FIRE SAFETY INSPECTION REPORT

LIDA TEXTILE & DYEING LIMITED

ACCORD ID: 12111

January 30, 2015

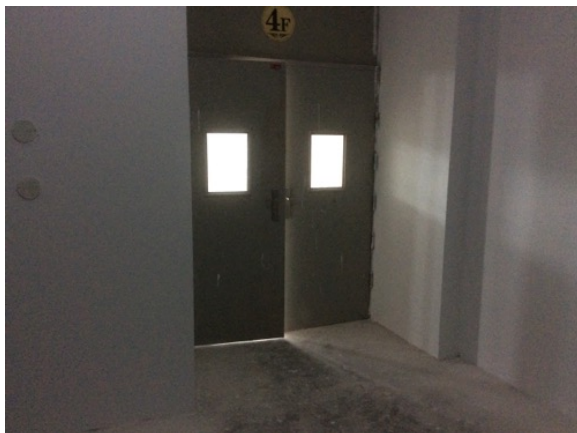
F-2	Fire Rated Construction	Unsealed penetrations and openings are located in exit stair enclosures.	Seal all penetrations and openings in exit stair enclosure walls to maintain the fire separation.	Within 3 months
